### BULLETIN NO. 6

491/20167.SDW - PHASE 500:  
CENTER FOR FORENSIC PSYCHIATRY- CREATE KITCHEN  
SALINE, MICHIGAN

WTA Project No. 2021094  
NOVEMBER 05, 2025

PROJECT NUMBER 2021094	SHEET NUMBER  A2.31
PROJECT DATE SEPTEMBER 6, 2023	
CHECKED BY C.D.S.

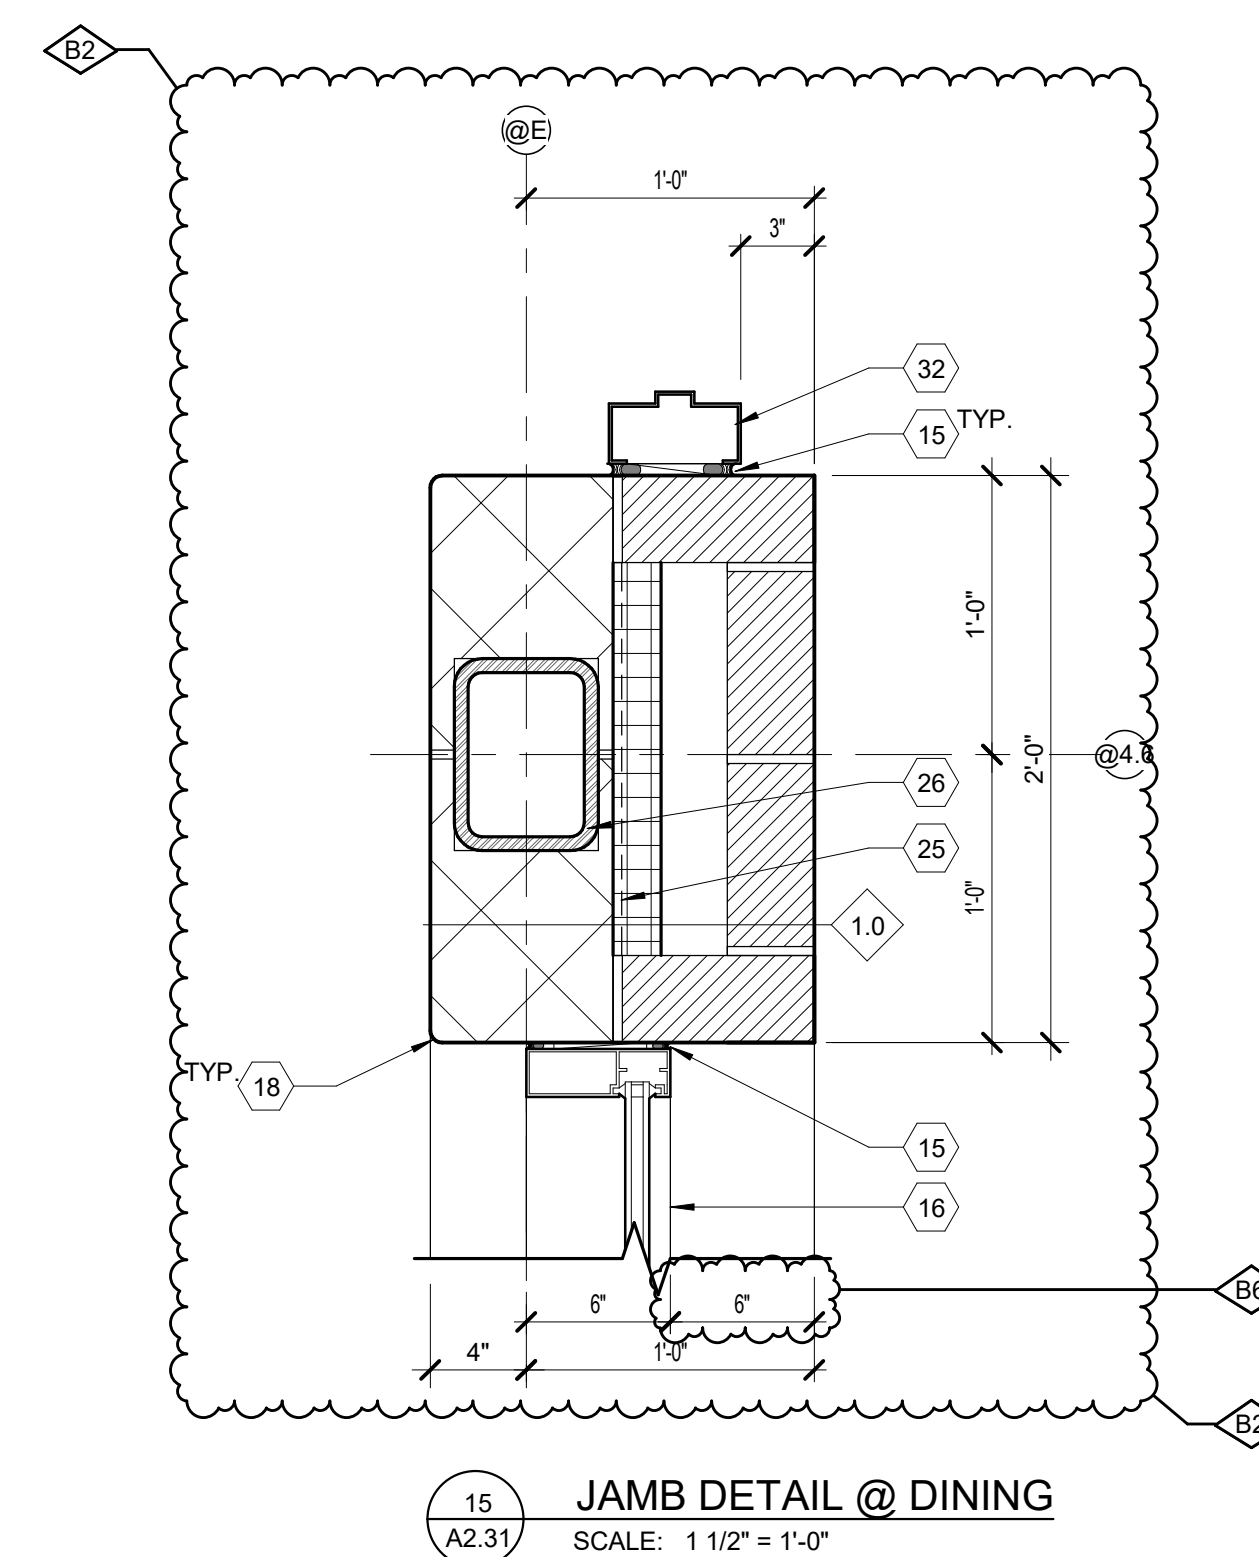
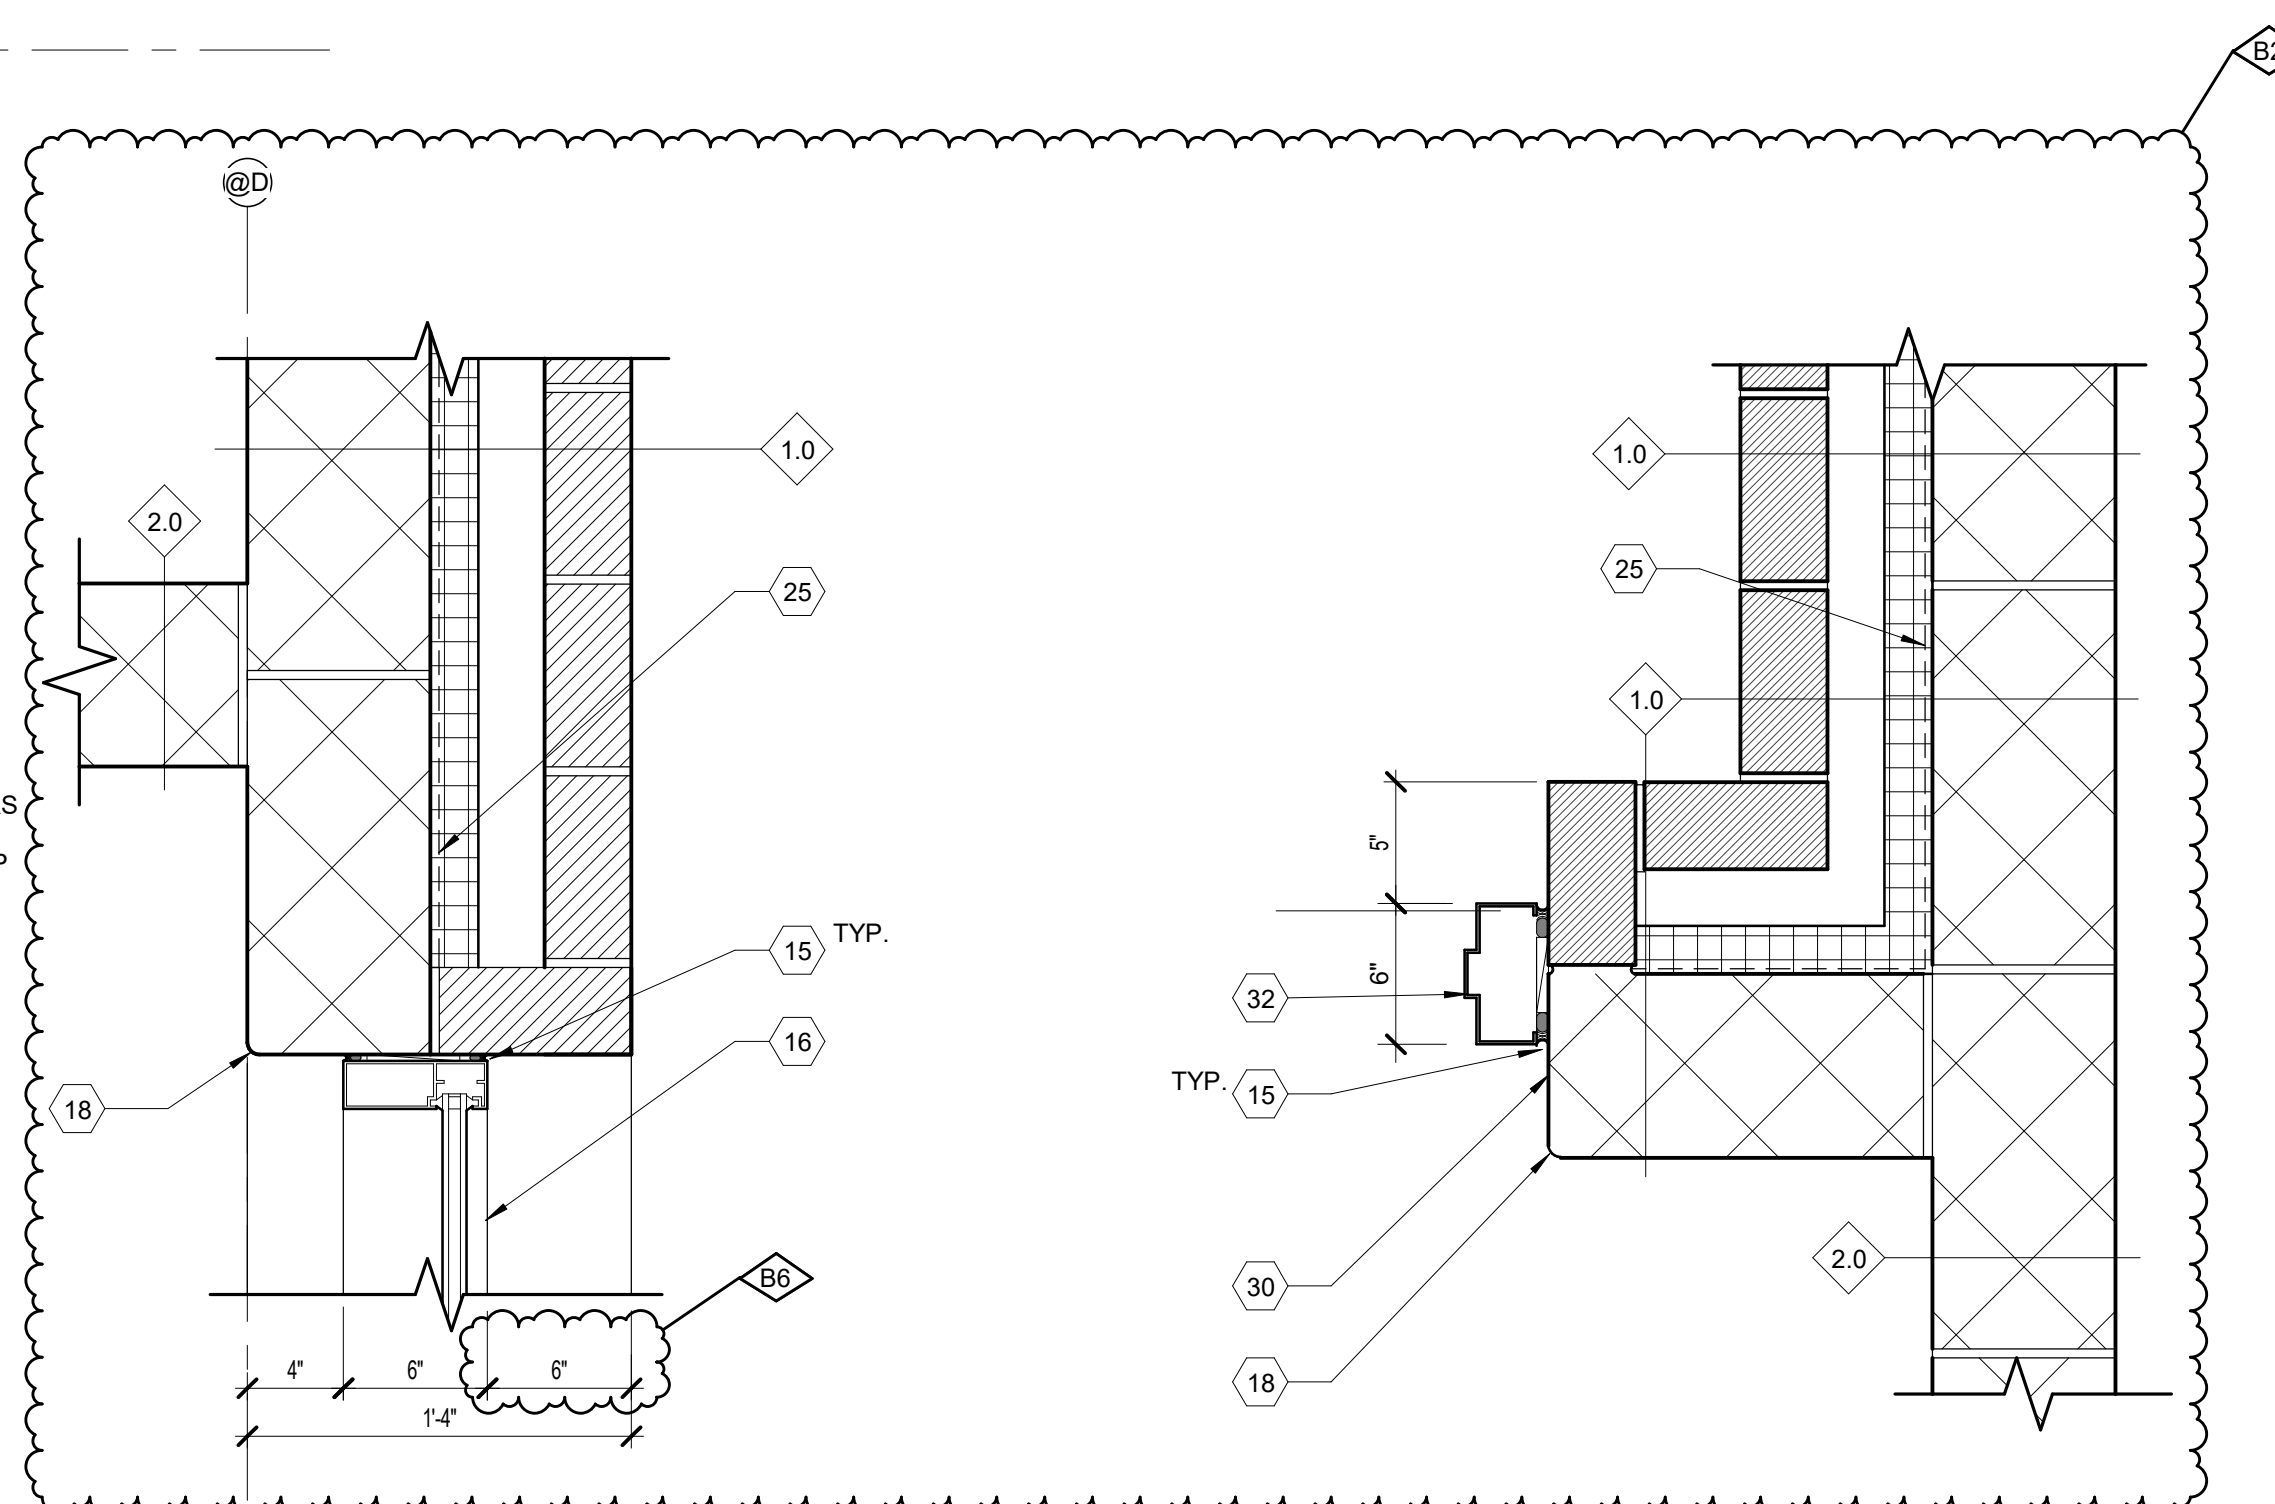
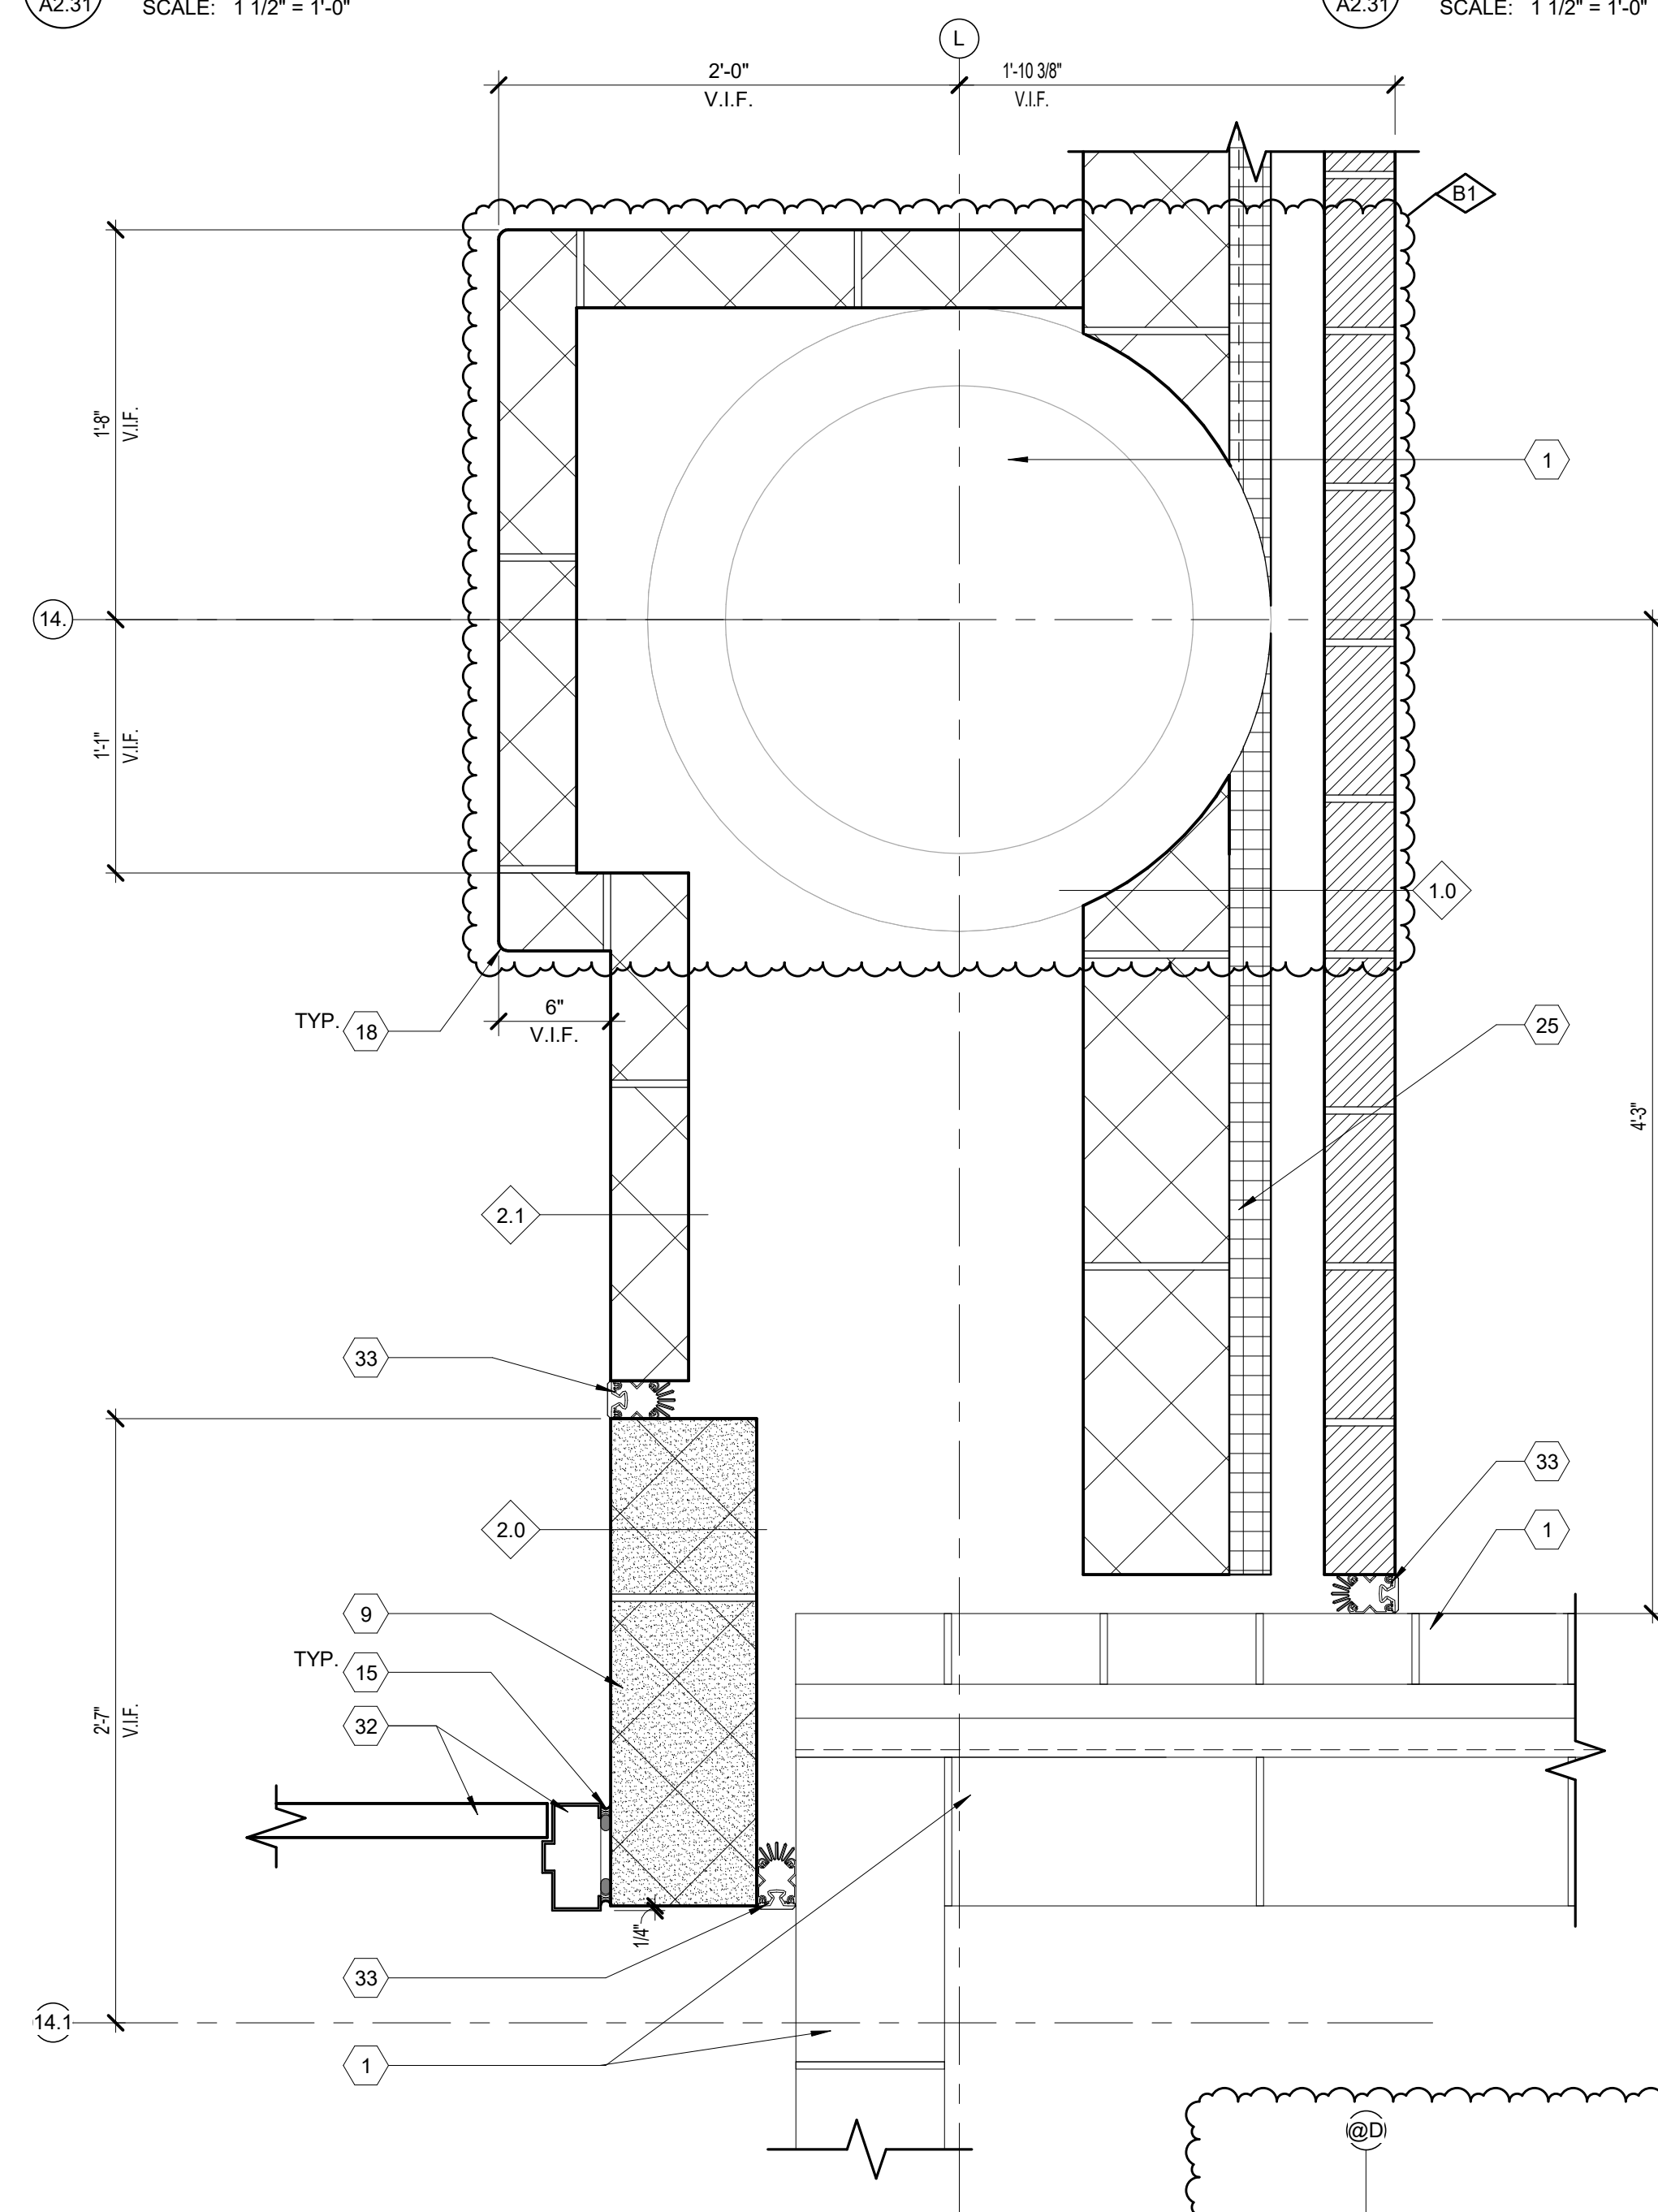
- Item A1      Reference Sheet A2.31, A7.01 **(Re-issued)**
- A. Revised windows to sit 6" from the face of the exterior wall in lieu of 3".
  - B. Added thru wall flashing, extruded aluminum flashing, and weeps under the window as indicated on attached sheets.
